KEYSTONE ELECTRONICS CORP.			
www.keyelco.com • NEW HYDE PARK NY 11040 • Tel (516)328-7500			
PART NAME			
FULLY INSULATED QUICK FIT TERMINAL MALE			
MATERIAL			
AS NOTED			
FINISH		DRN BY	DATE
AS NOTED		NT	6.09.09
		APP'D	SCALE
		MR	2X
TOLERANCES	INCH [MM]	CODE	DWG NO.
DECIMAL	± .010 [± 0.25]	C	8299
ANGULAR	± 1°		
UNLESS OTHERWISE SPECIFIED

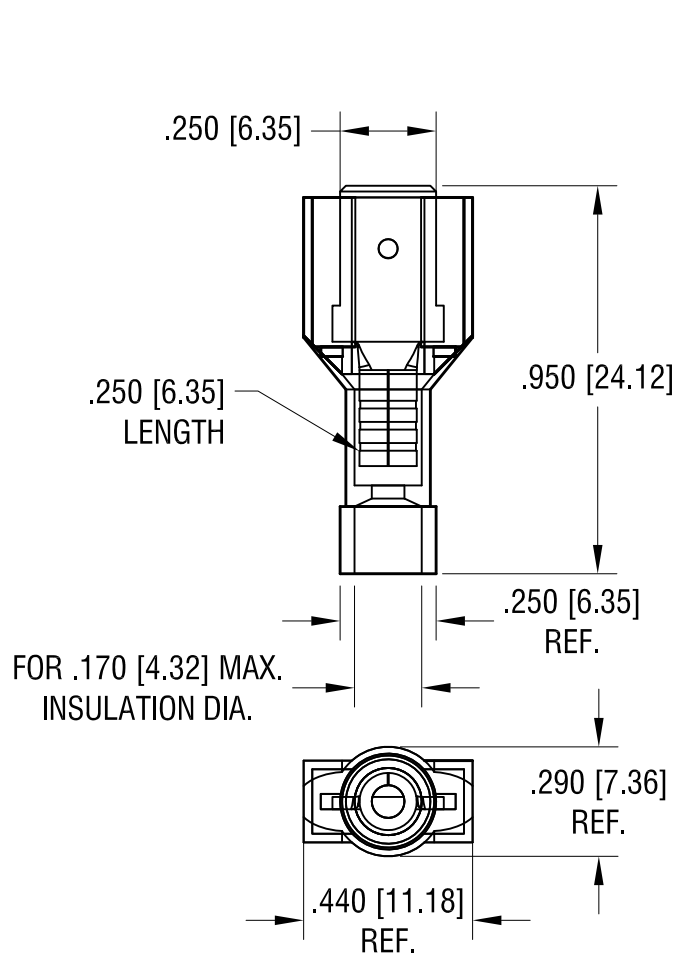
4.10.25 UPDATED AS PER NEW TOOLING.
CHANGE AS PER PCN 25-024.
